ADDENDUM

NO. 2

PROJECT NAME: New Operations Building

ADDENDUM DATE: Thursday, January 29, 2026

MECHANICAL FLOOR PLAN -
LEVEL 1 / 2 - AREA A / C -
OPERATIONS BUILDING

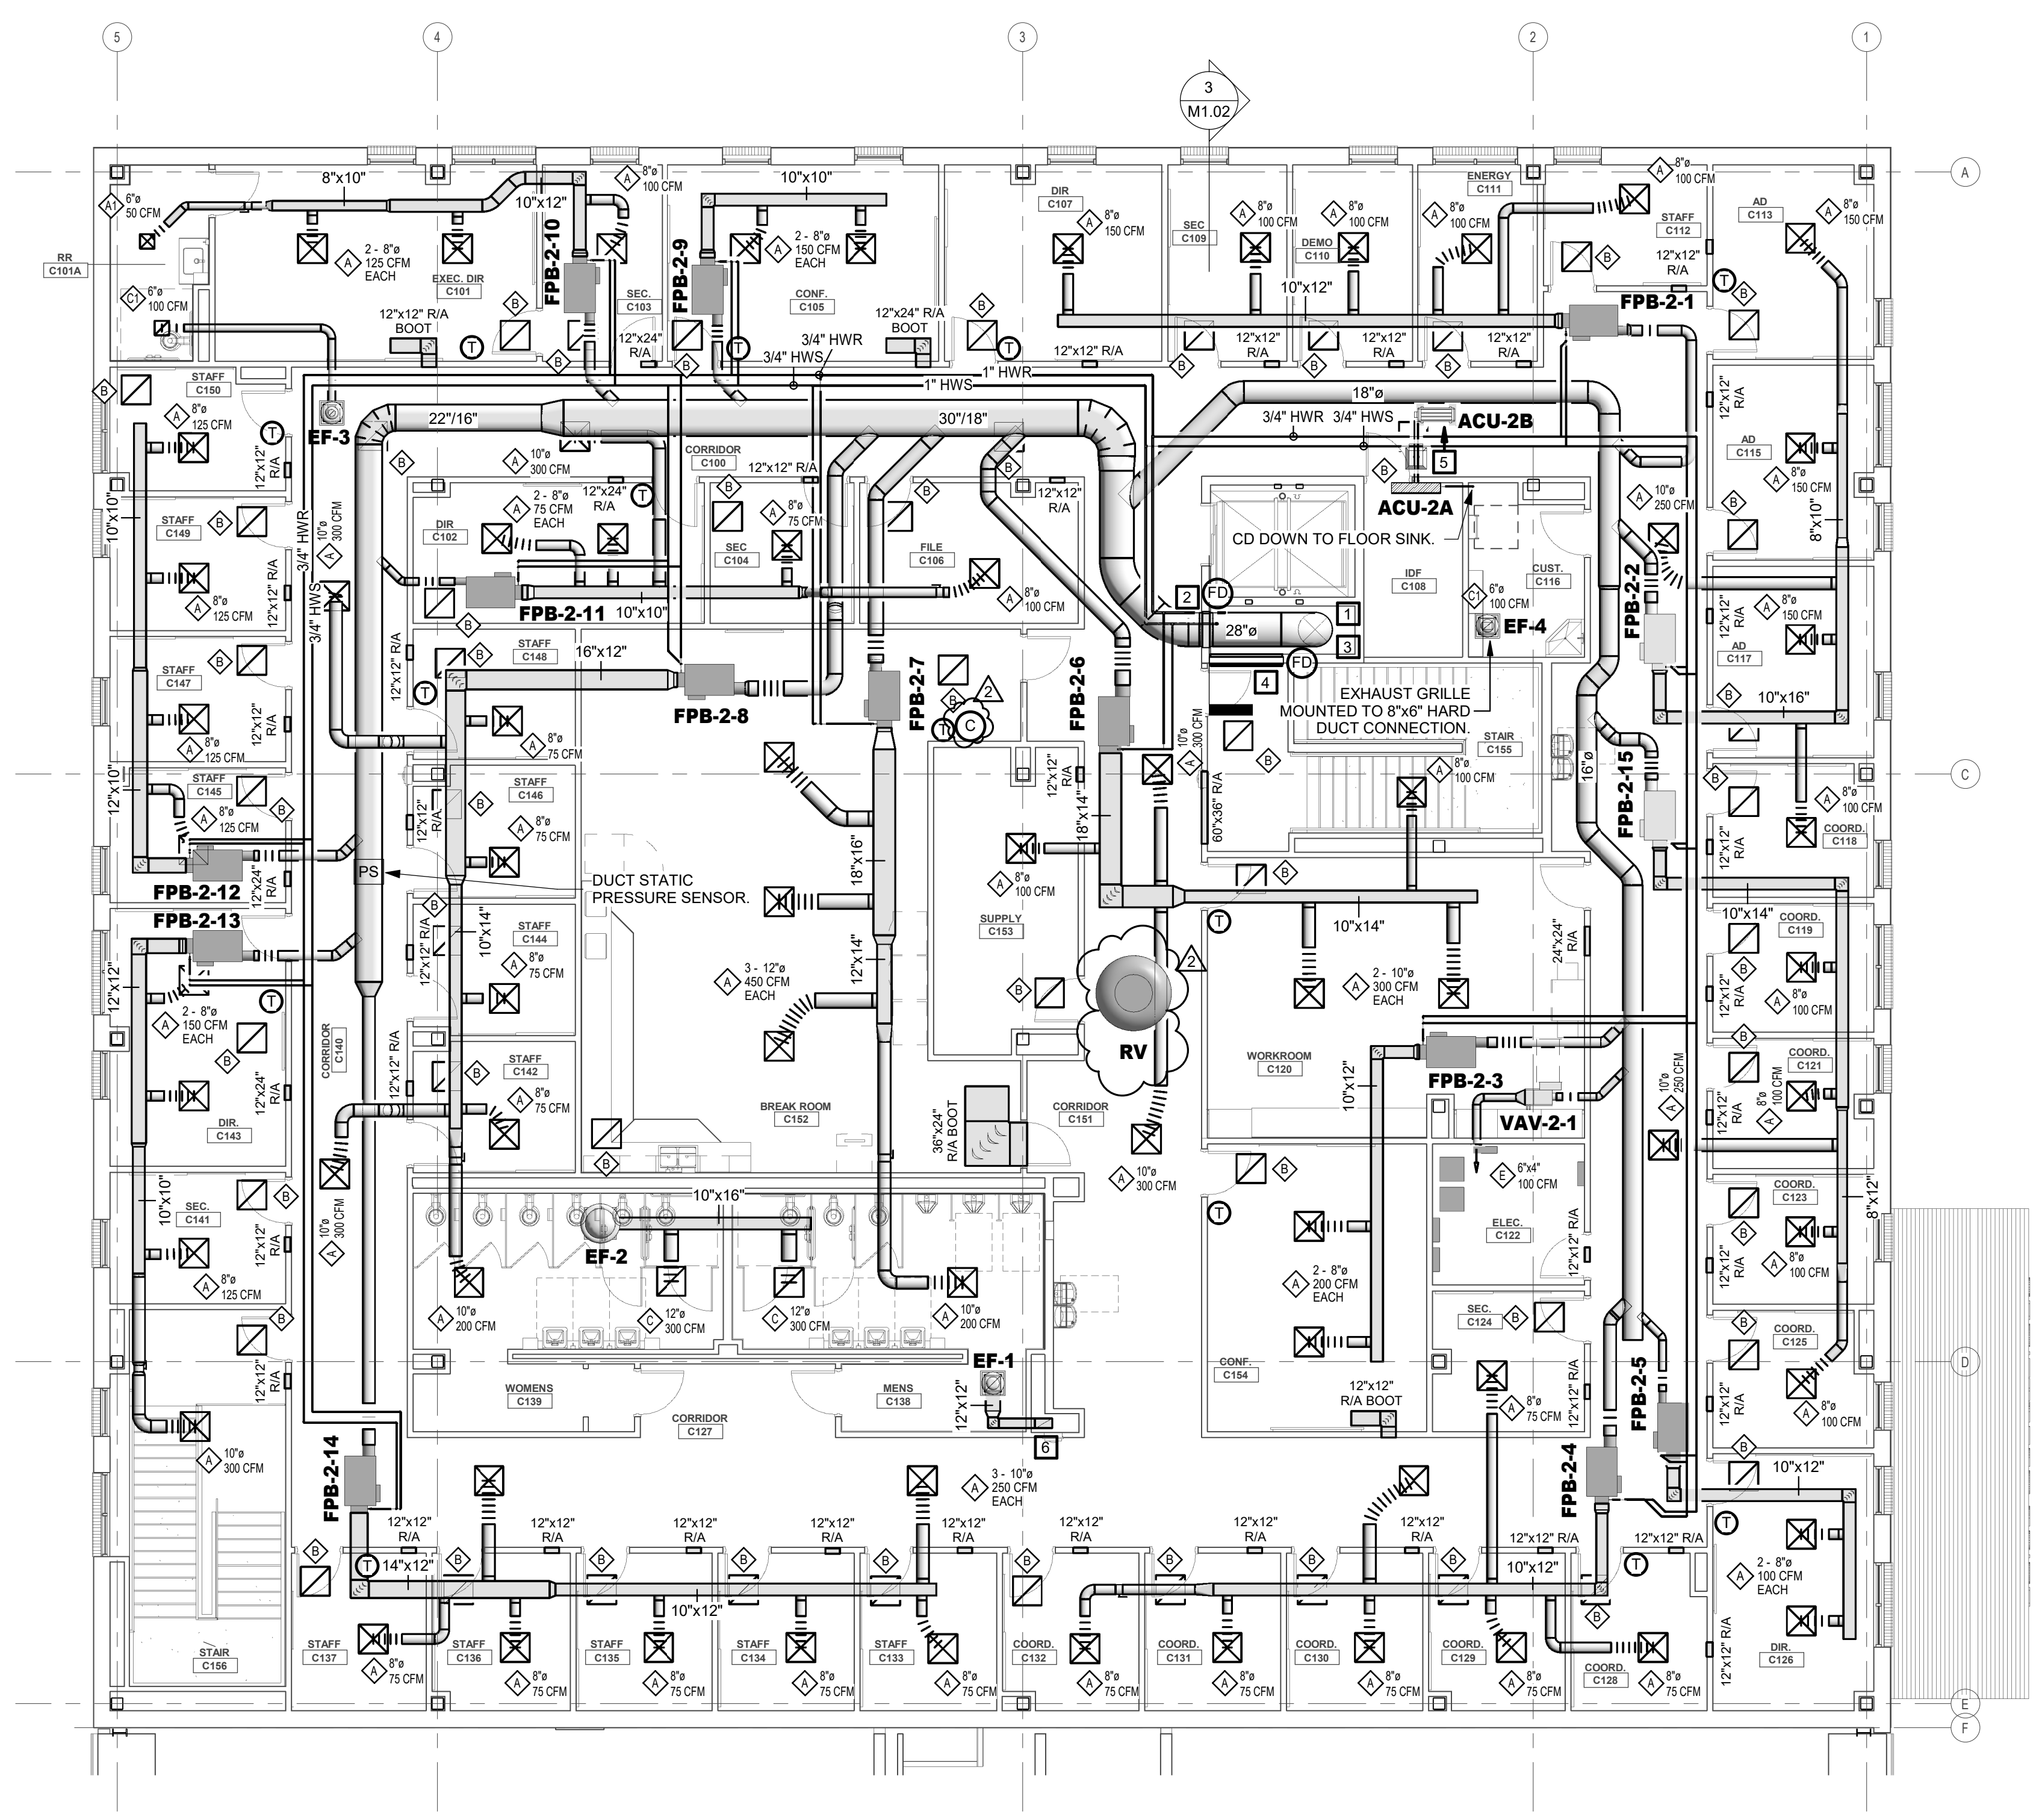
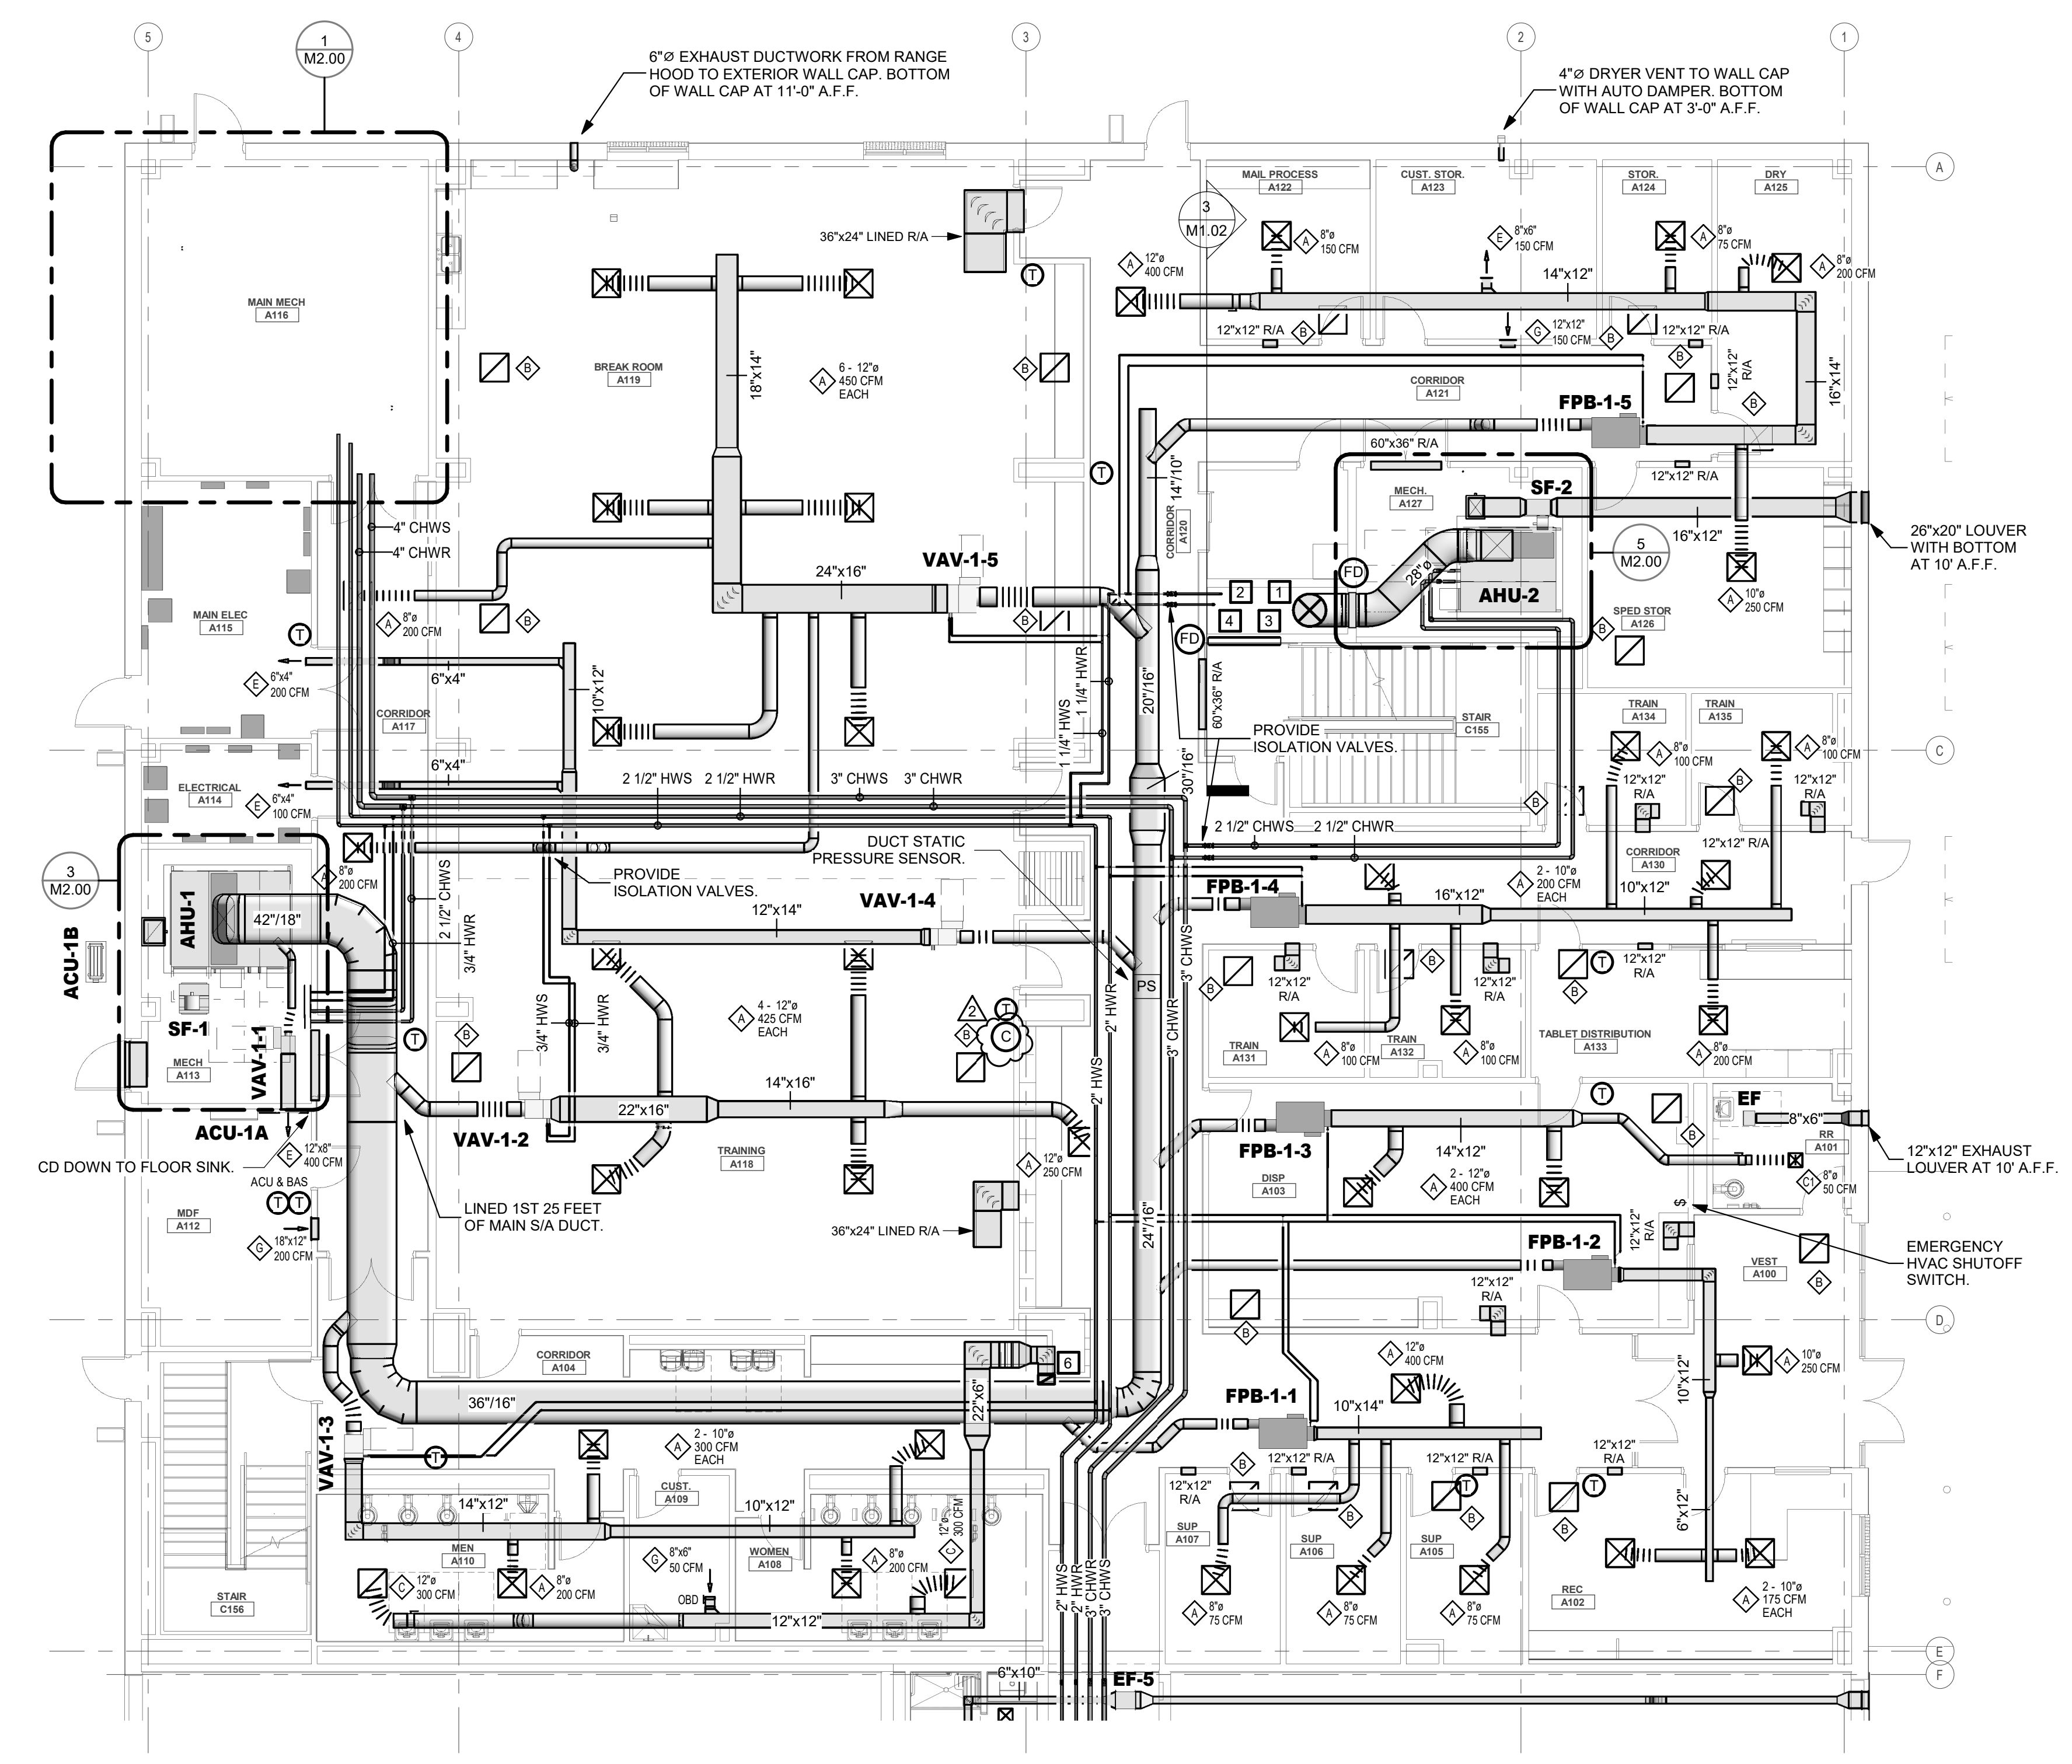
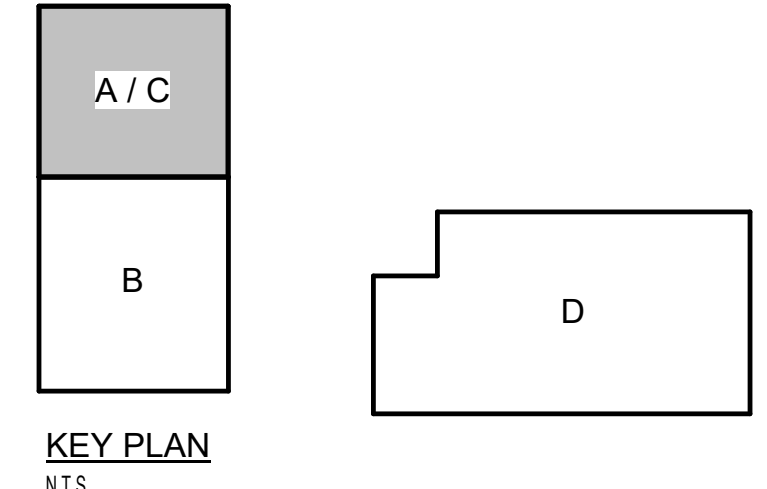
AD No 1, Mech. Item 1: To the Drawings, Sheet M1.02, "MECHANICAL FLOOR PLAN – LEVEL 1 – 2 – AREA A – C – OPERATIONS BUILDING,"

- 1) 2nd Floor - Add relief vent RV on roof.
- 2) A118 – Add CO2 sensor.
- 3) C152 – Add CO2 sensor.
